# RENESAS TECHNICAL UPDATE

Product Category	MPU/MCU		Document No.	TN-RX*-A005A/E	Rev.	1.00
Title	The correction of errors in the I2C Bus Interface (RIIC) Hardware Manual		Information Category	Technical Notification		
Applicable Product	RX610 Group RX62N、RX621 Group RX62T Group	Lot No.	Reference Document	RX610 Group RX62N、RX621 Group RX62T Group Hardware Manual		
		All Lot

Figure xx.10 Example of Master Reception Flowchart (7-Bit Address Format)

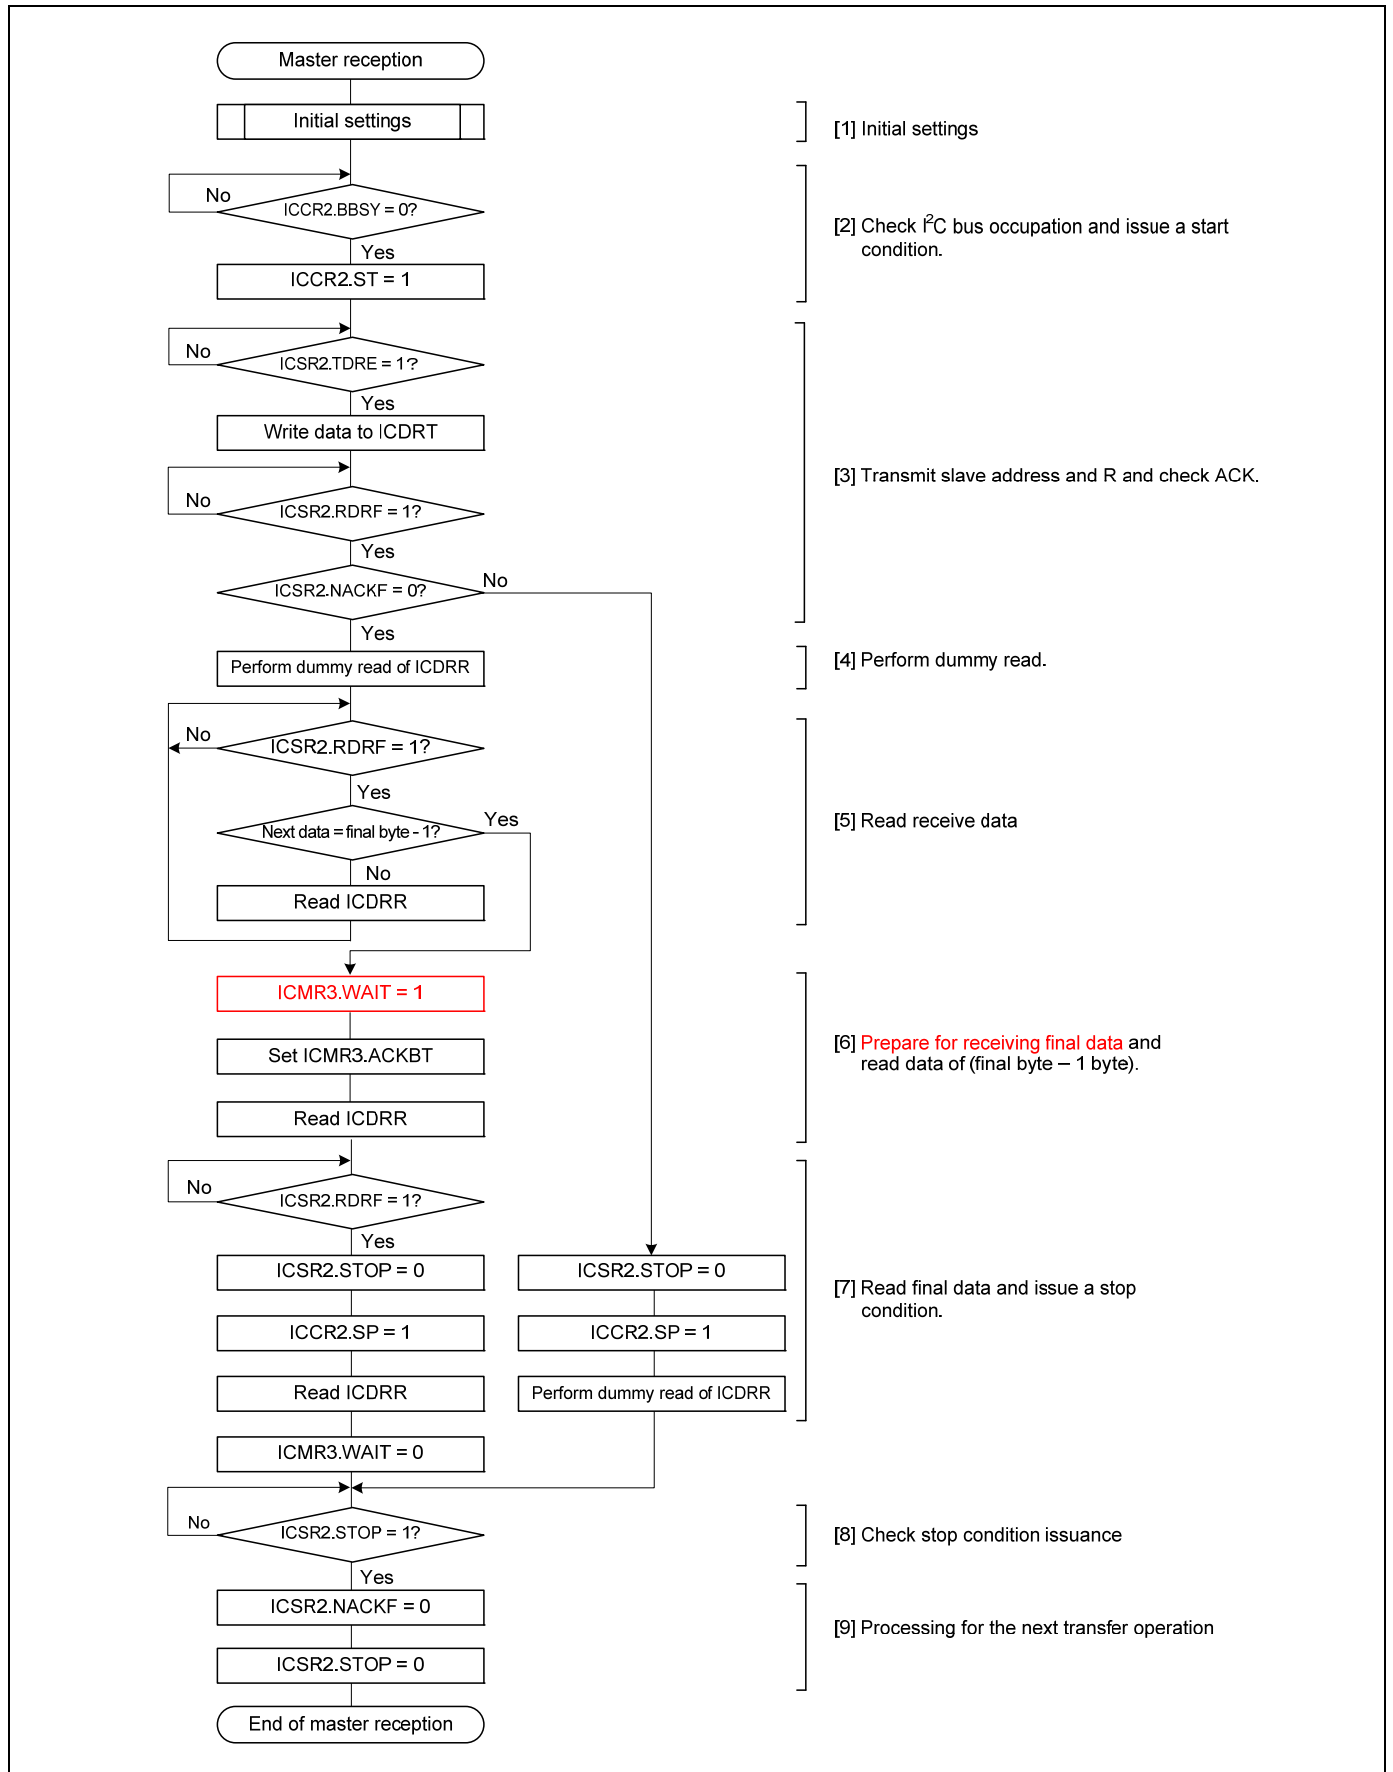
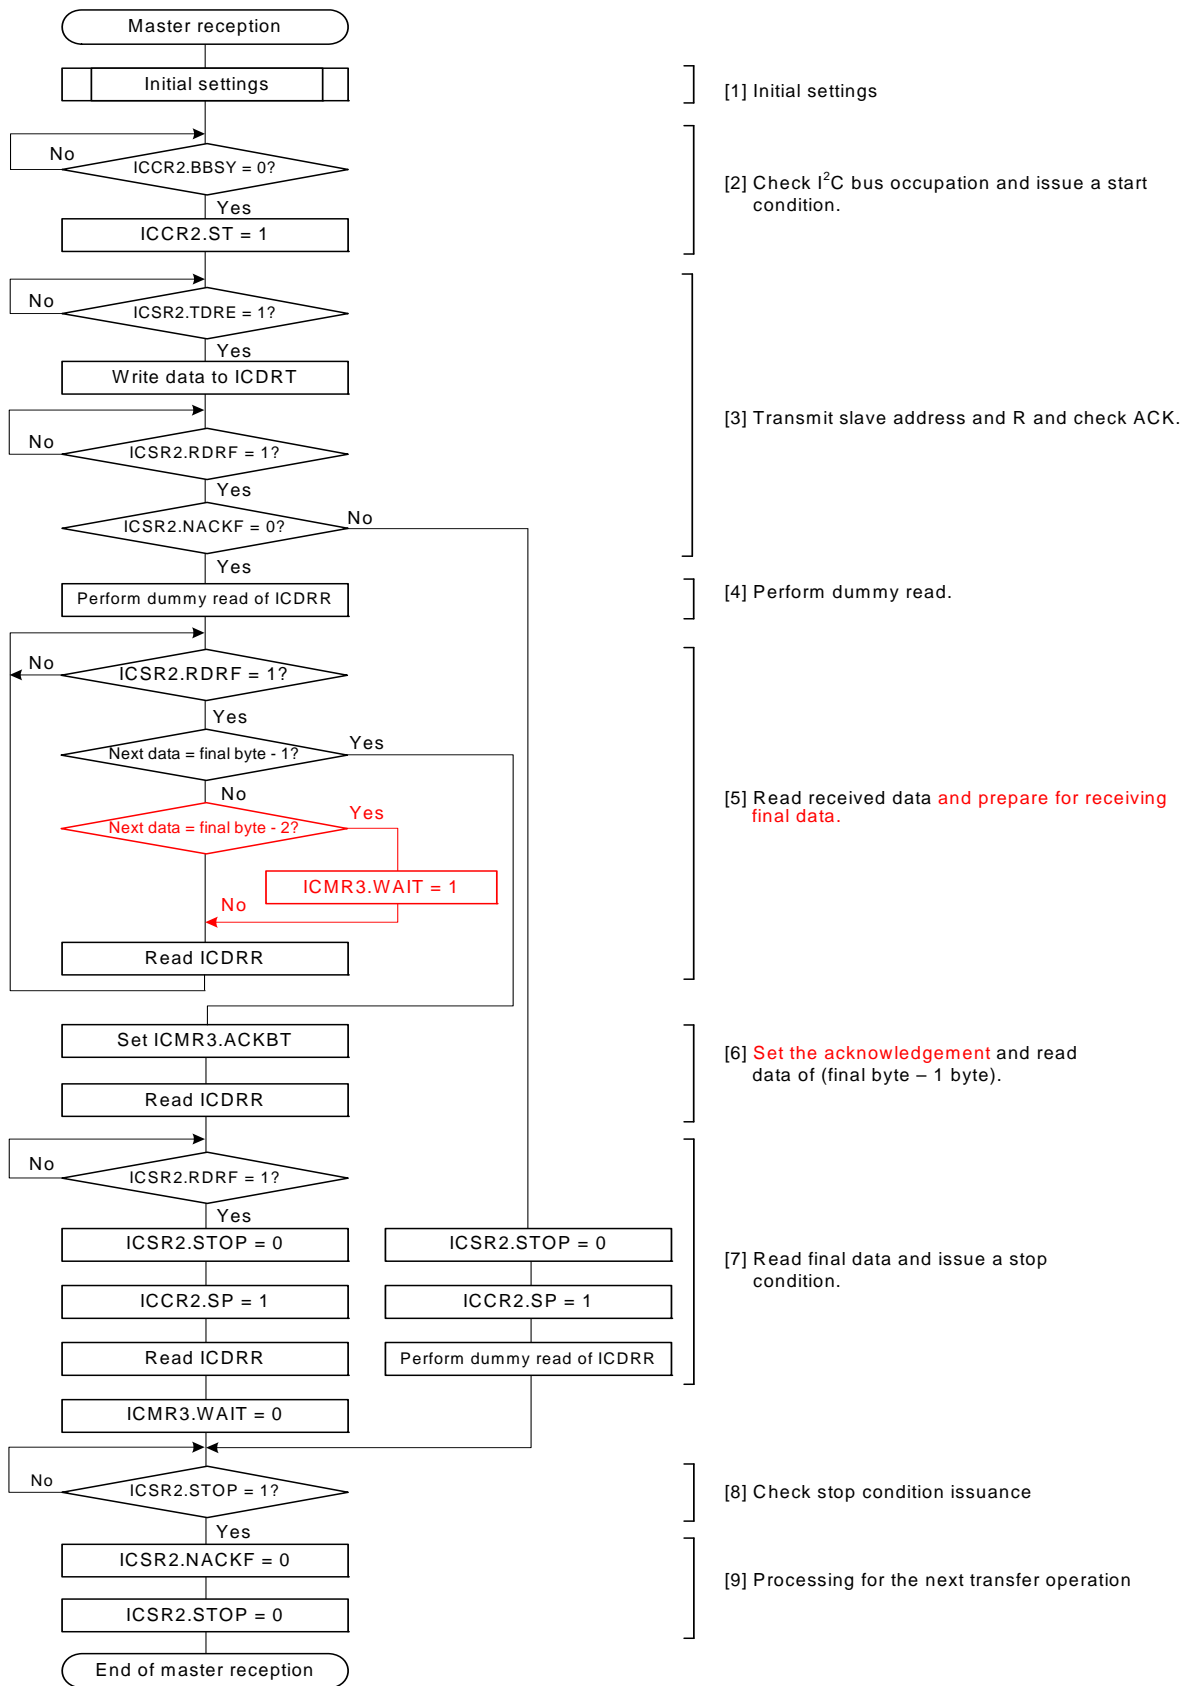
2. The corrections of errors 「xx.3.4 Example of Master Reception Flowchart」

Figure xx.13 Master Receive Operation Timing (3) (when RDRFS=0)

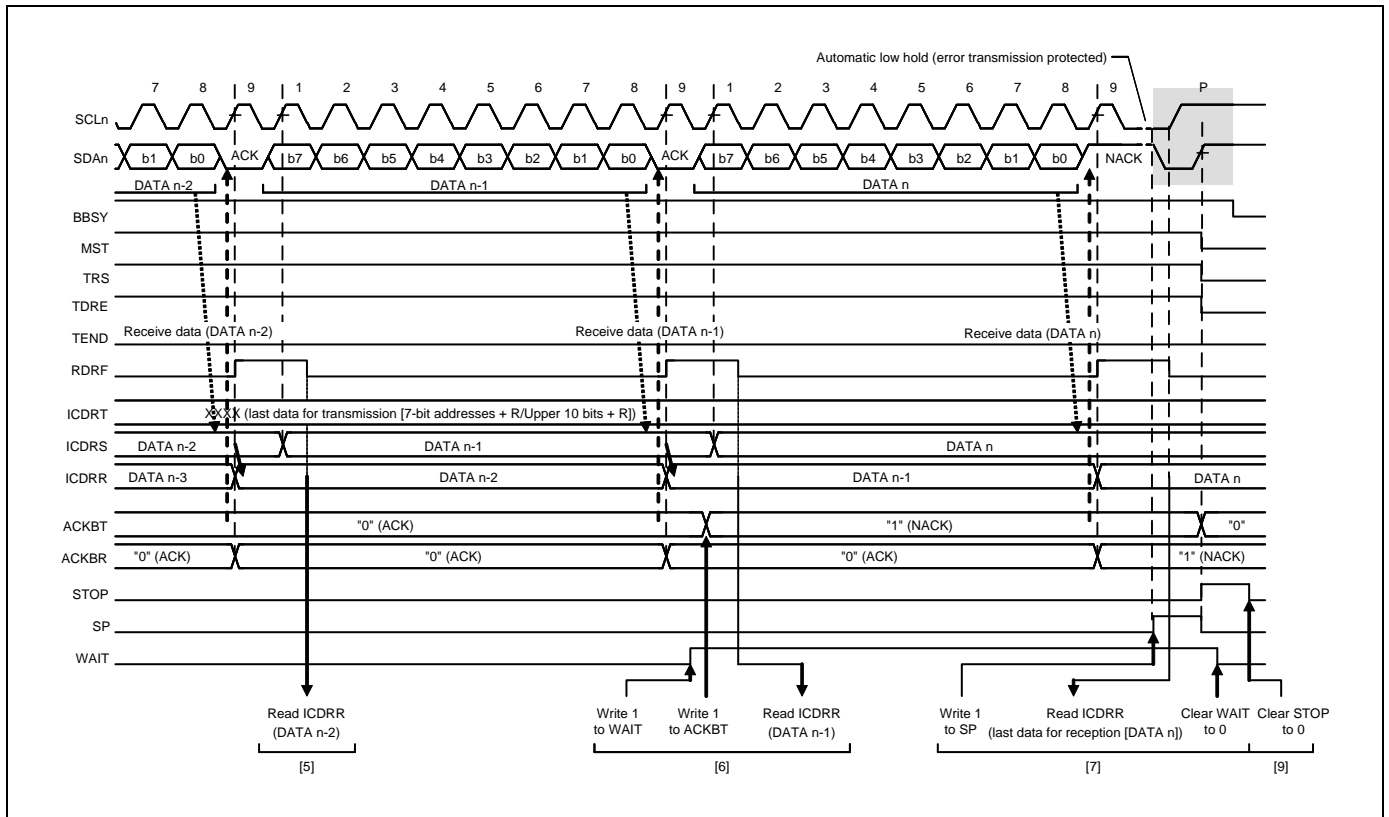
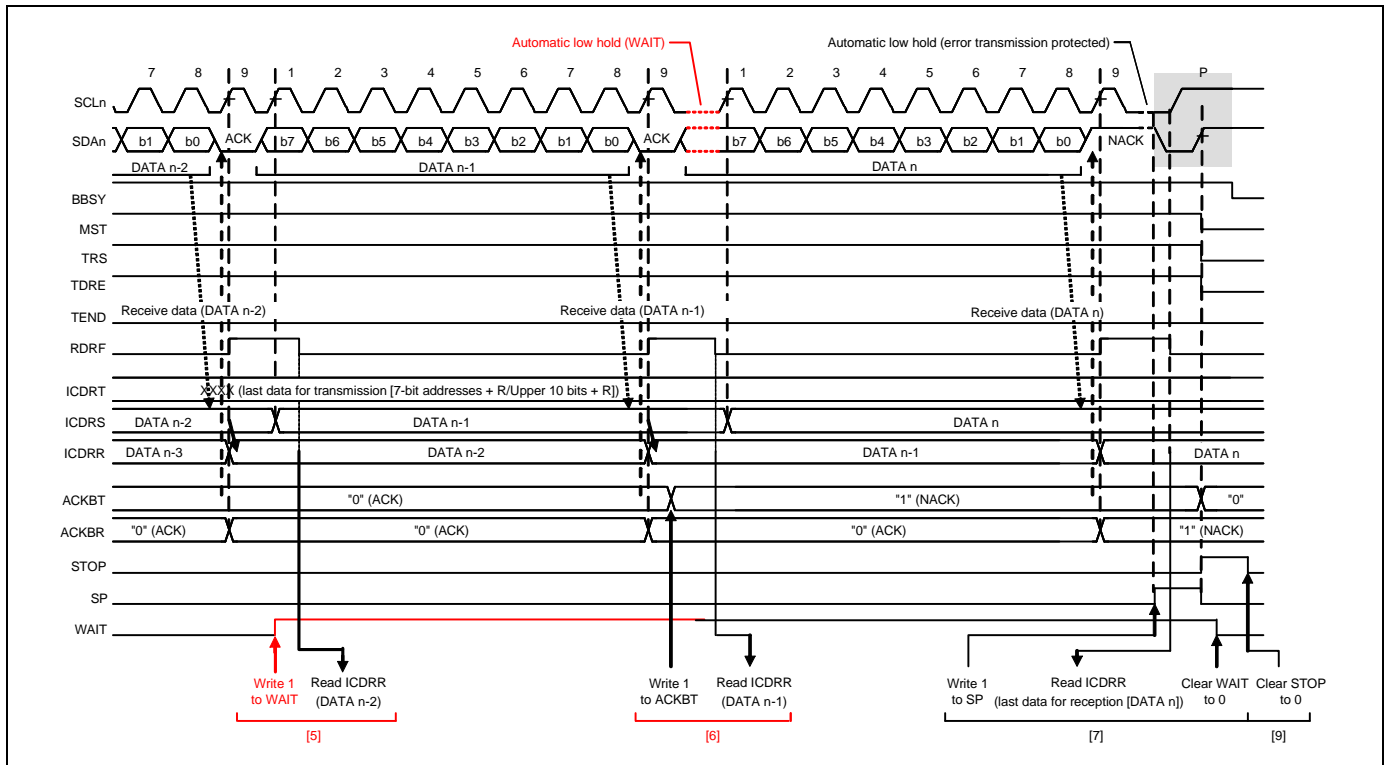
3. The corrections of errors 「xx.3.4 Master Receive Operation Timing (3)」
